Product Change Notice

Product : Samsung LH231B (SCPTJ5HEL1*****)**

Change : Manufacture site

Remark : Effective June, 2023

0. How to distinguish

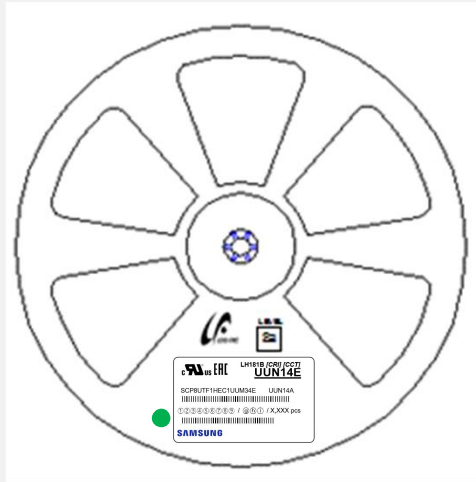
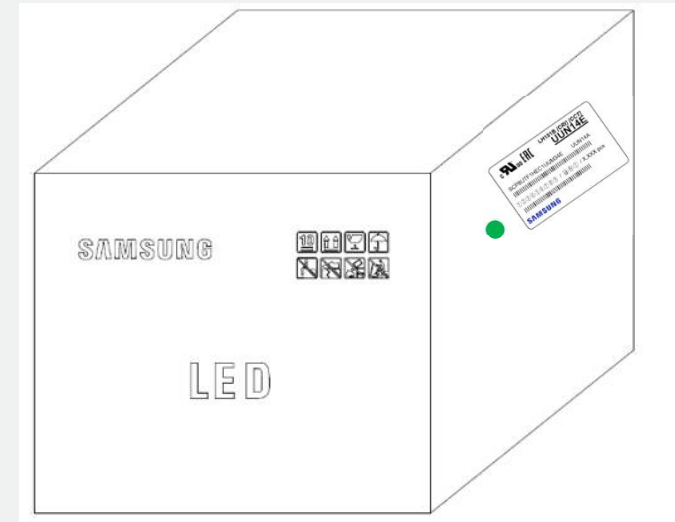
- China product apply green mark on reel, vinyl bag and box.

※ Recommendation : Do not use old mixed with new products when assembling modules.

1. Change Anode Mark

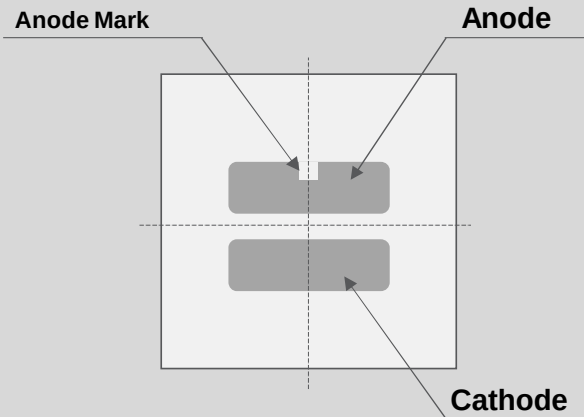
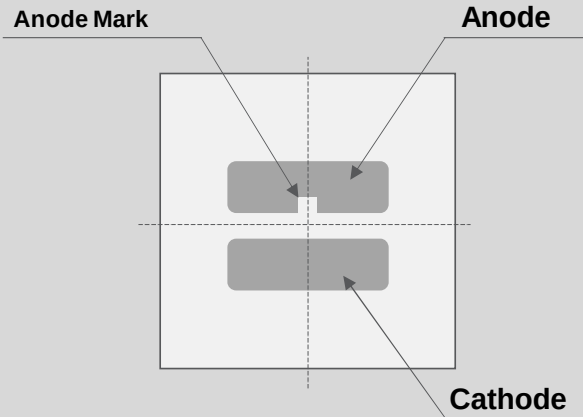
- Changed direction anode mark from outside to inside.

3. Comparison electrical sweep

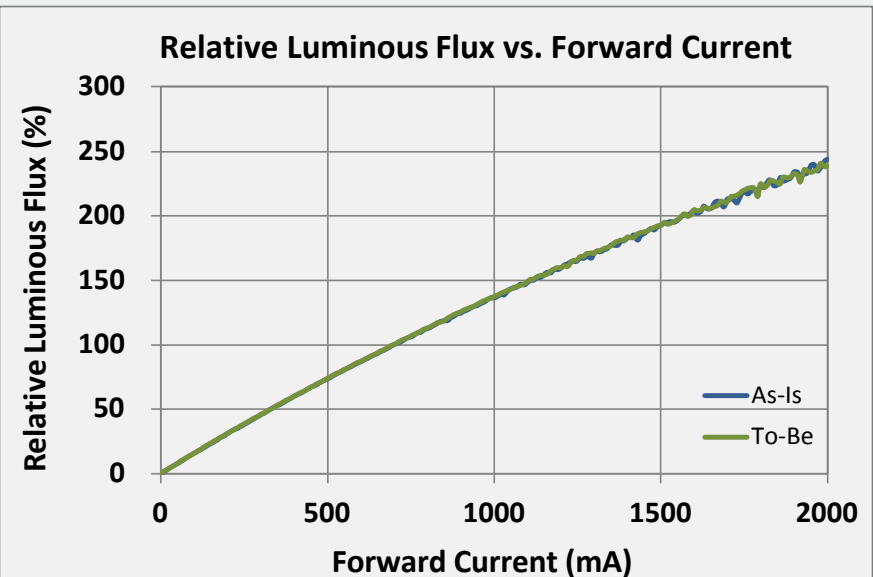
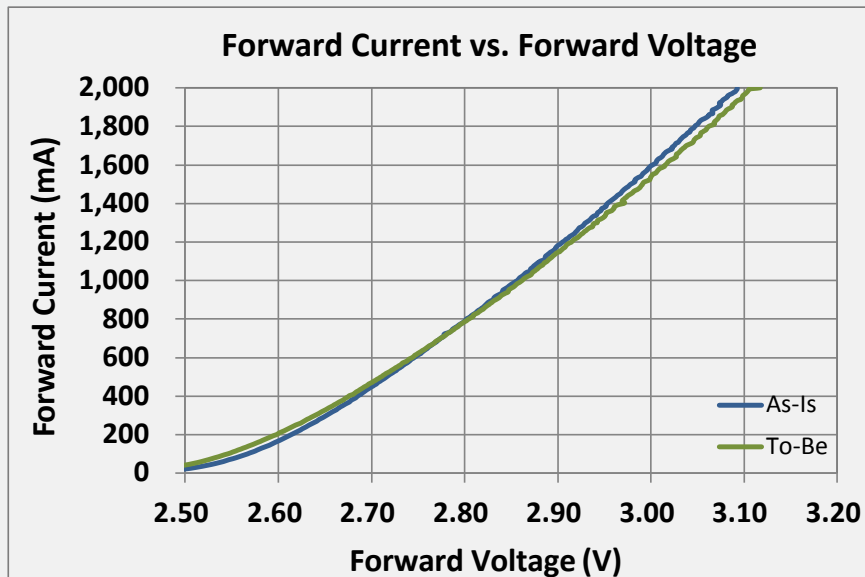
- Substantially same

4. Comparison thermal sweep

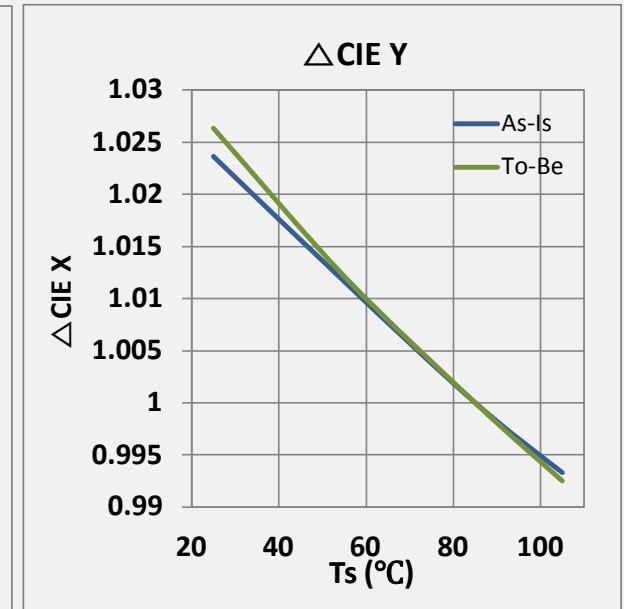
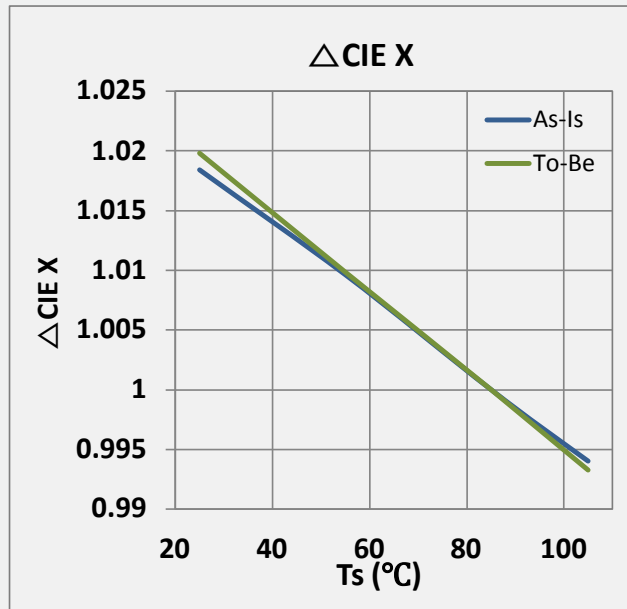
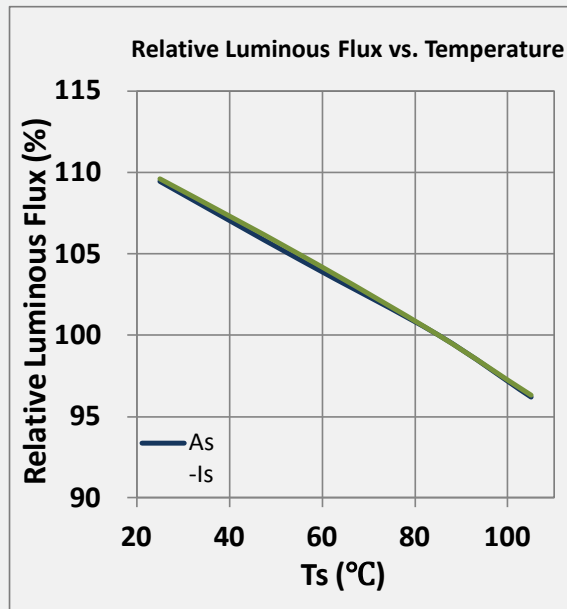
- Substantially same

5. Comparison COA

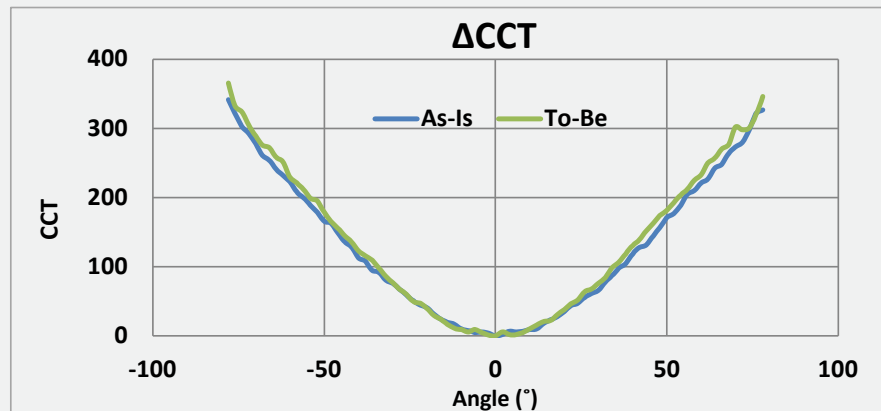
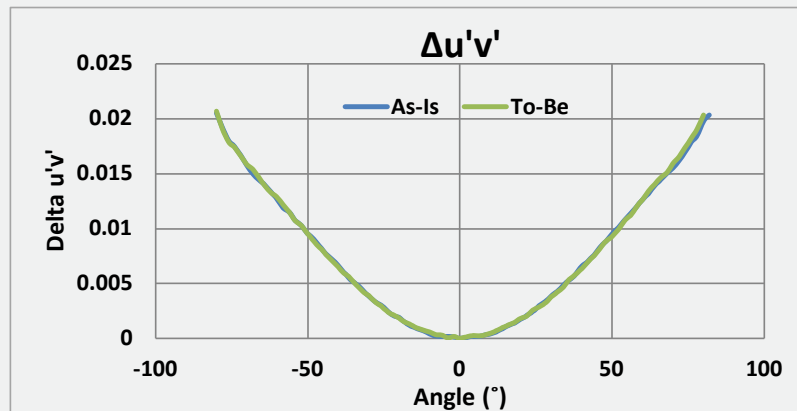
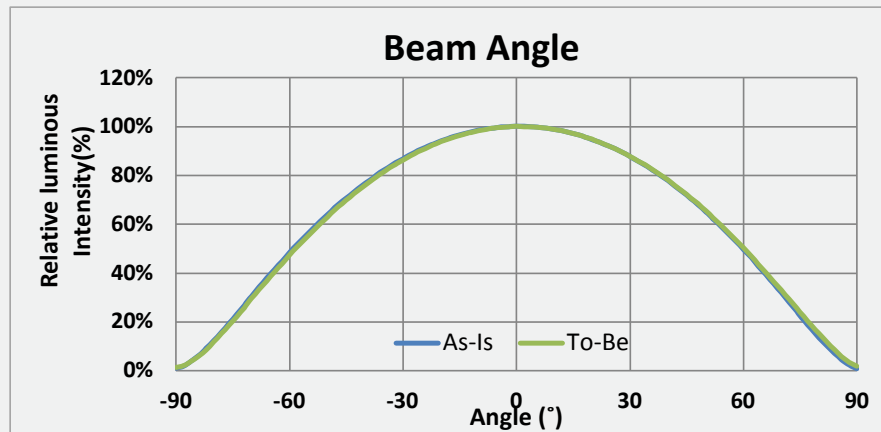
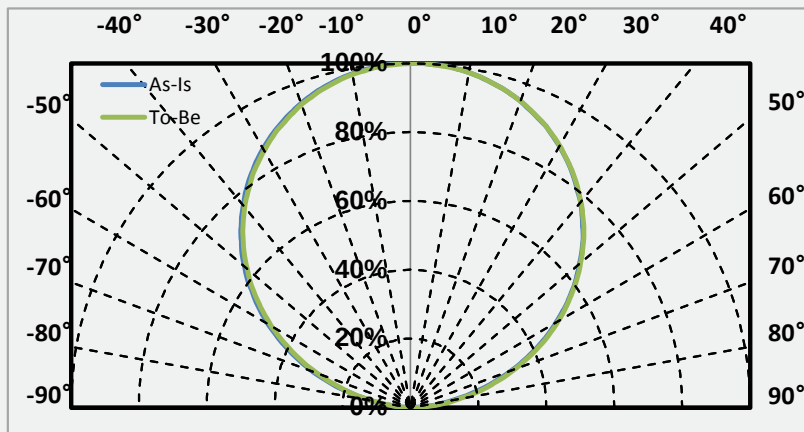
- Substantially same

6. Reliability Test Results of new P/N

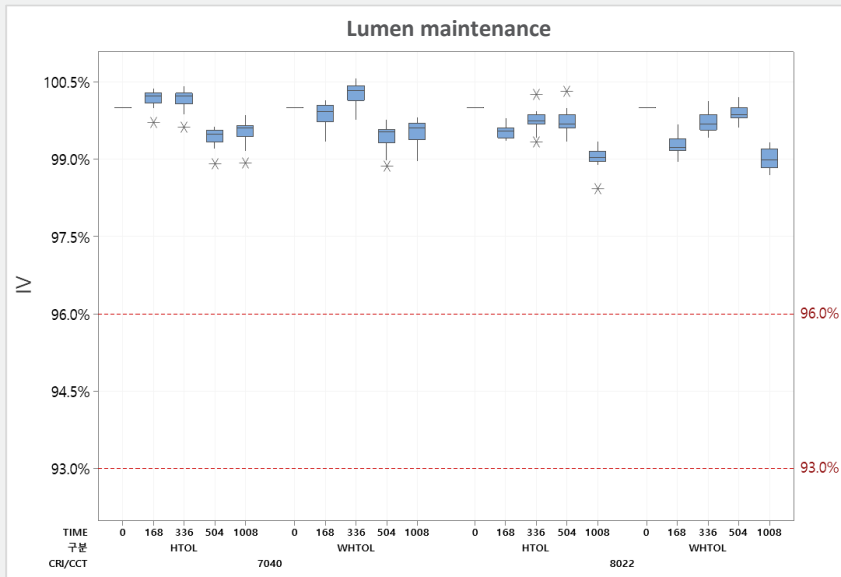
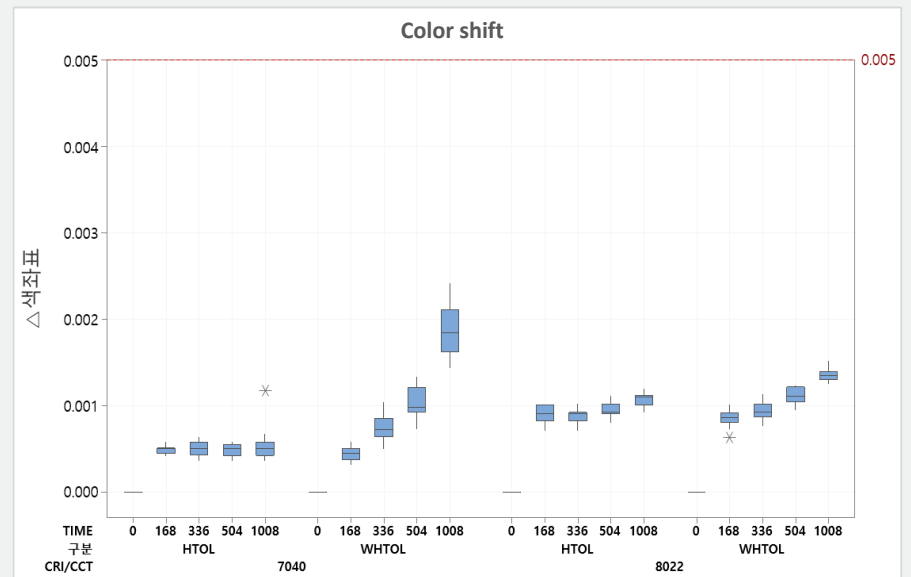
■ Operating Reliability test (HTOL, WHTOL) : Pass

Test	HTOL (85°C) (1008hr)			WHTOL (85°C/85%RH) (1008hr)			T/C (-45~125°C, Each 15min)
	ΔVF	ΔI_m	$\Delta u'v'$	ΔVF	ΔI_m	$\Delta u'v'$	
Result	99.8%	99.5%	0.0005	100.3%	99.5%	0.0019	700cyc Pass
